## 8730 GREENWOOD AVE N.

RECOMMENDATION  
#3036533-LU 04/19/2021

EARLY DESIGN GUIDANCE RESPONSES | MASSING OPTIONS & RESPONSE TO ADJACENCIES

WEST ELEVATION ALONG GREENWOOD AVE N

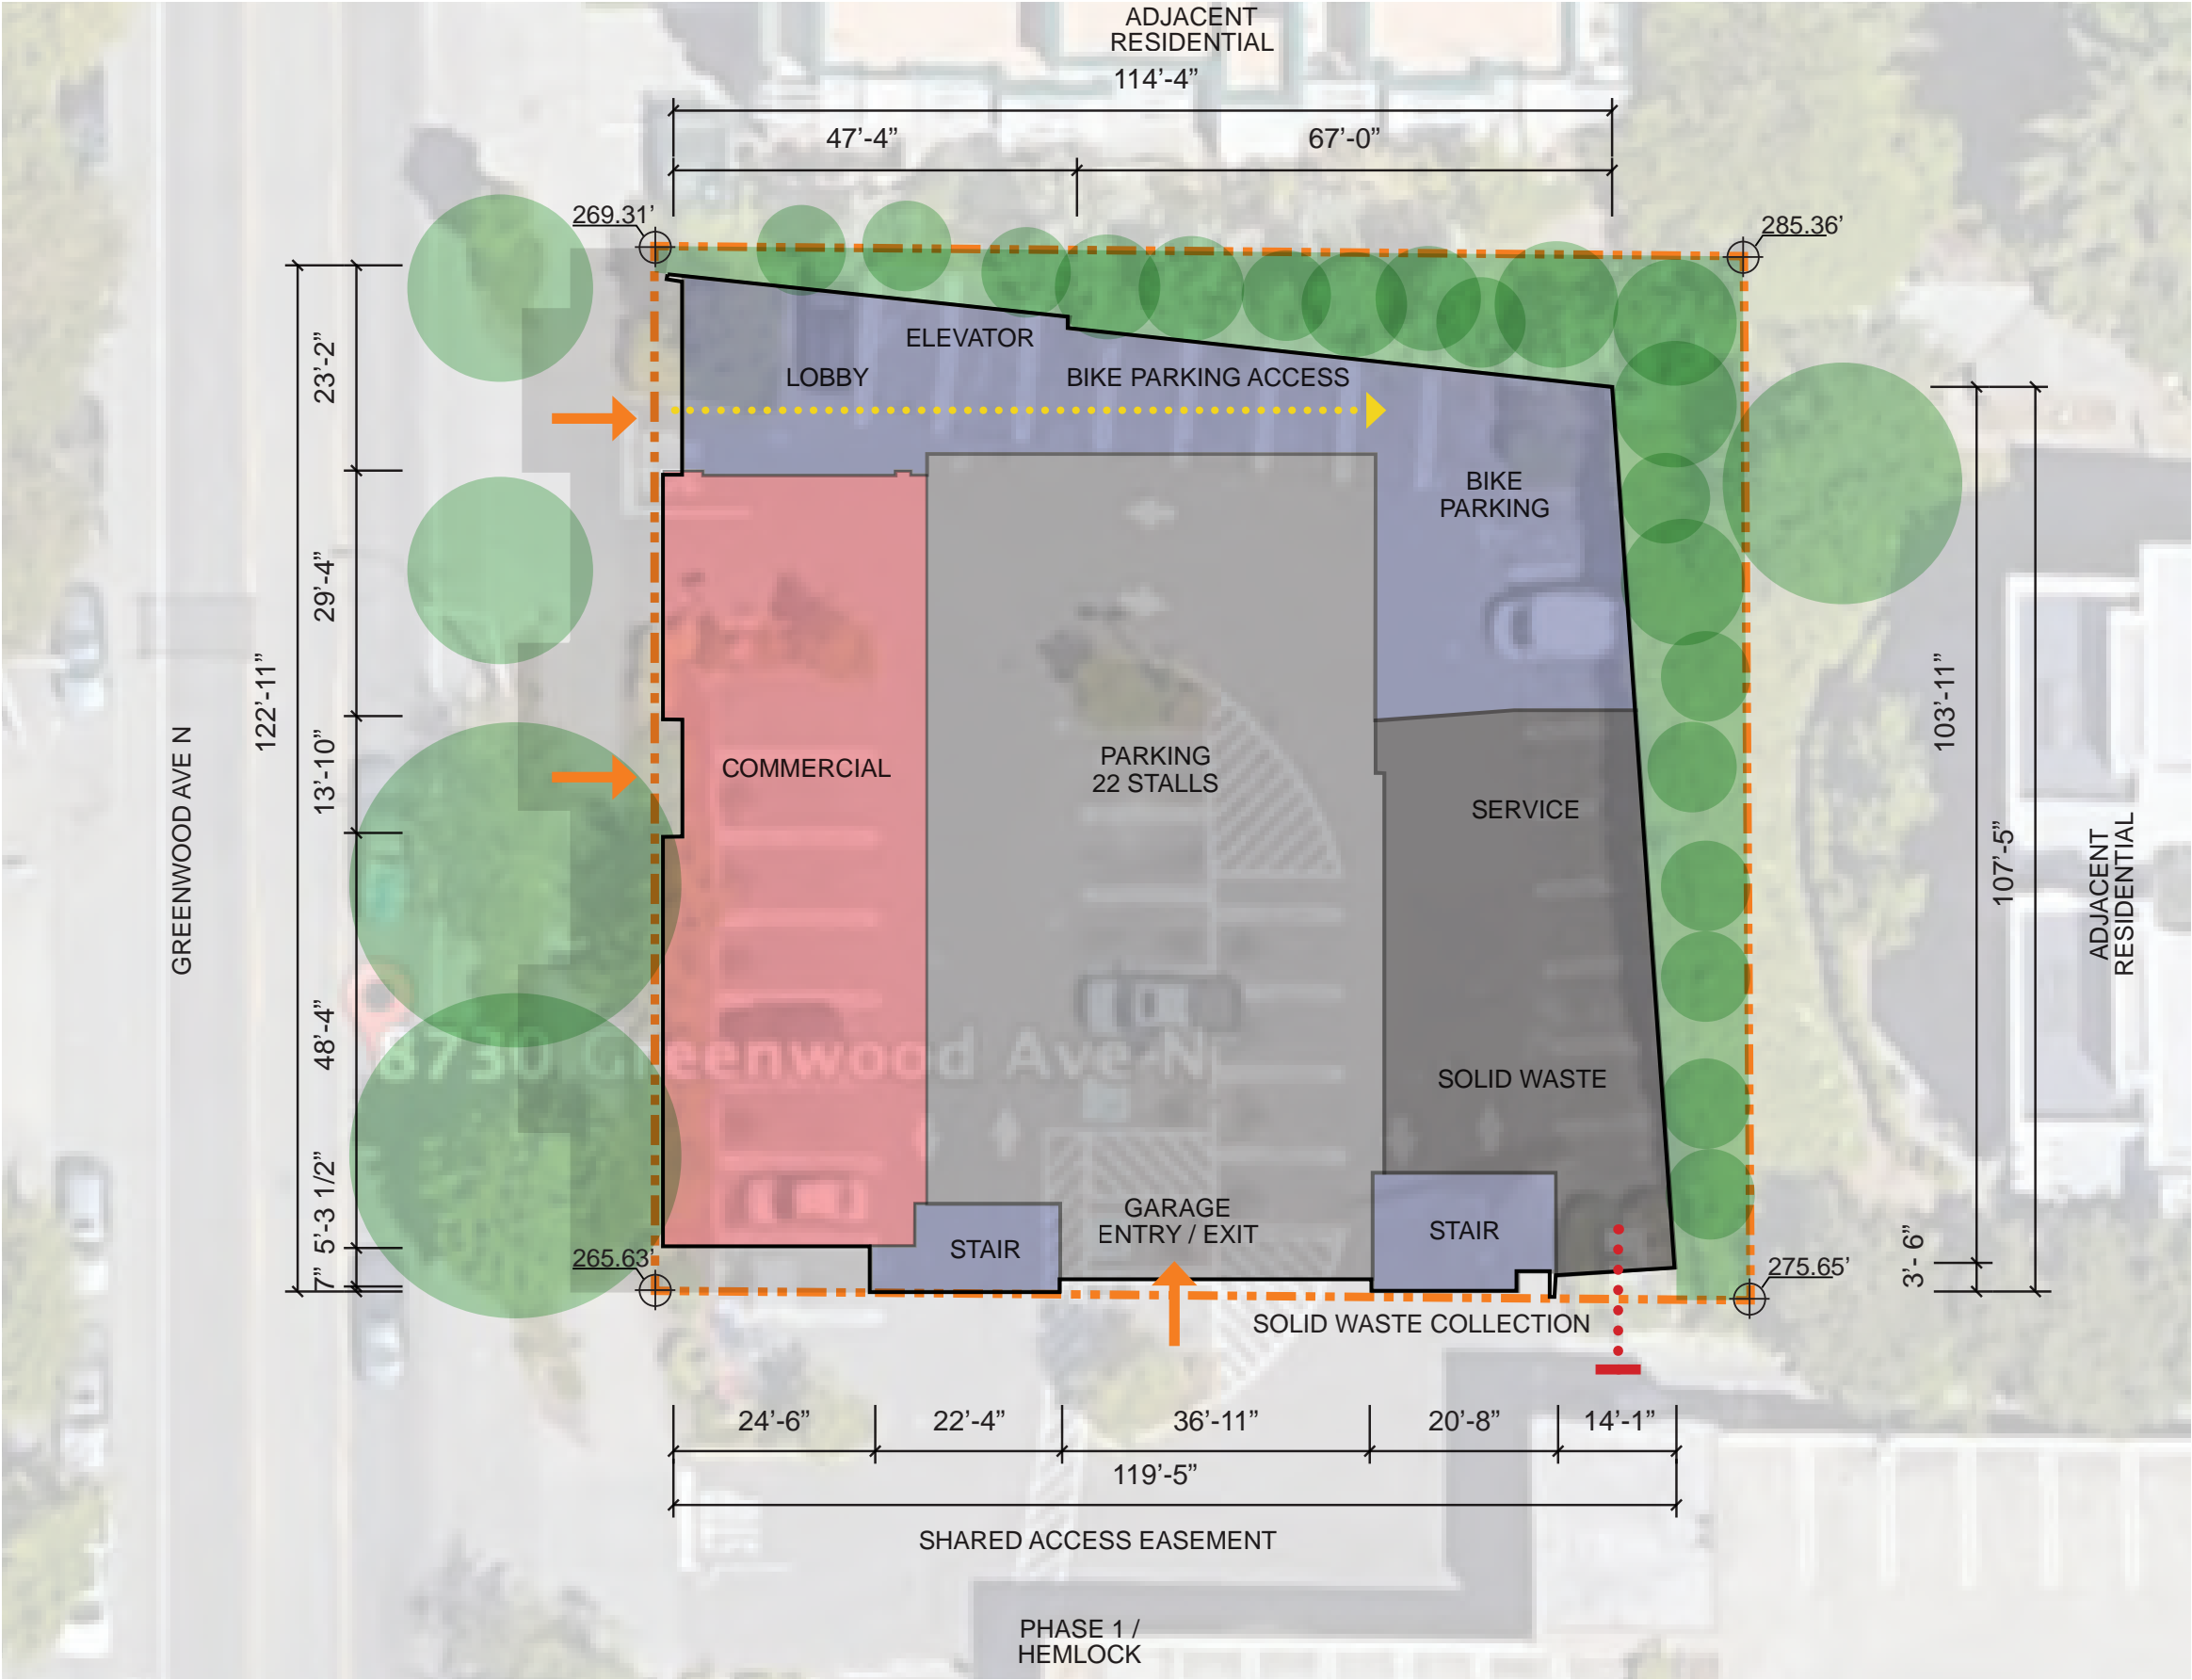
Board Guidance:

The board appreciated efforts to both respond to and differentiate the project from Phase 1 and requested the applicant provide an elevation study at the Recommendation phase showing the relationship of the proposal with the adjacent structures including datum lines and the overall streetscape composition.

At the recommendation phase the Board would like to better understand the relationship of the material palette with the materials of Phase 1 to the south.

Applicant Response:

*The tone and distribution of the materials from the early design guidance character sketch has continued to evolve, but maintained key attributes from the earlier concept. A neutral brick tone that complements the metal siding on the upper stories was selected to also contrast the red / orange Phase 1 / Hemlock masonry color. The physical proportions and expression of the street level brick frames are similar but a lighter more neutral brick tone is used. This color change provides differentiation to mitigate what could otherwise read as a single, long facade at street level. Additionally the proposed color better complements the darker upper level materials. A similar contrast occurs at the upper levels, where the adjacent Hemlock utilizes a lighter toned siding with dark vertical accents, the proposal utilizes a darker primary siding tone w/ a contrasting lighter vertical volume at the residential entry. A warm but vibrant accent color enlivens the composition and juxtaposes the otherwise neutral color palette.*
